Product Change Notification / SYST-08MPXV615

ERRATA - dsPIC33CH512MP508 Family Silicon Errata and Data Sheet Clarification

dsPIC33CH512MP508 Family Silicon Errata and Data Sheet Clarification

FIGURE 1-1: I/O RAMP

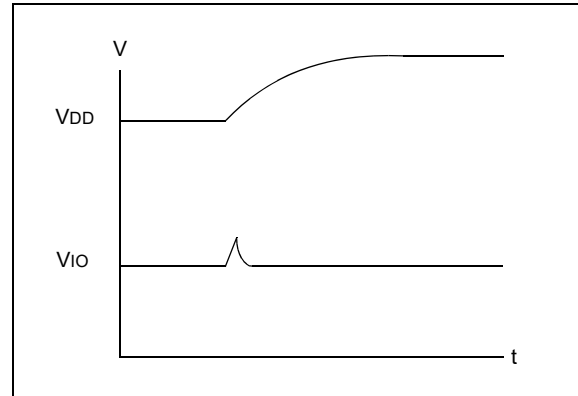
During a fast device power-up, when the VDD ramp is less than 4 mS, the I/O pins may drive up to 100 μ A current for a duration of up to 10 μ S (Figure 1-1).

1. Slow down the VDD ramp time (greater than 4 mS for VDD to ramp 0V to 3.3V).
2. Ensure the circuitry that is connected to the pins can endure this pulse.

Example applications affected may include complementary power switches, where a transient current shoot-through might occur. High-voltage applications with complementary switches should power the high-voltage 200 μ Sec later than powering the dsPIC[®] device to avoid the current shoot-through. This behavior is specific to each device and not affected by aging.

FIGURE 2-2: SUGGESTED PLACEMENT OF THE OSCILLATOR CIRCUIT

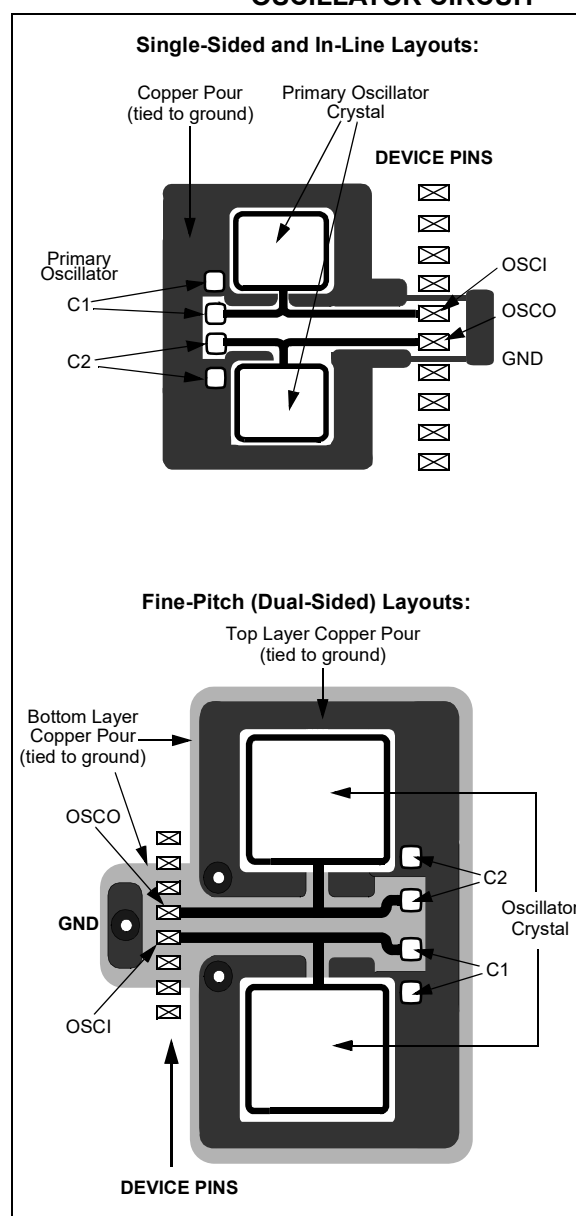
Additional information is added to [Section 2.5 “External Oscillator Pins”](#) and [Section 2.6 “External Oscillator Layout Guidance”](#) is added.

Use best practices during PCB layout to ensure robust start-up and operation. The oscillator circuit should be placed on the same side of the board as the device. Also, place the oscillator circuit close to the respective oscillator pins, not exceeding one-half inch (12 mm) distance between them. The load capacitors should be placed next to the oscillator itself, on the same side of the board. Use a grounded copper pour around the oscillator circuit to isolate it from surrounding circuits. The grounded copper pour should be routed directly to the MCU ground. Do not run any signal traces or power traces inside the ground pour. If using a two-sided board, avoid any traces on the other side of the board where the crystal is placed. Suggested layouts are shown in [Figure 2-2](#). With fine-pitch packages, it is not always possible to completely surround the pins and components. A suit-

able solution is to tie the broken guard sections to a mirrored ground layer. In all cases, the guard trace(s) must be returned to ground.
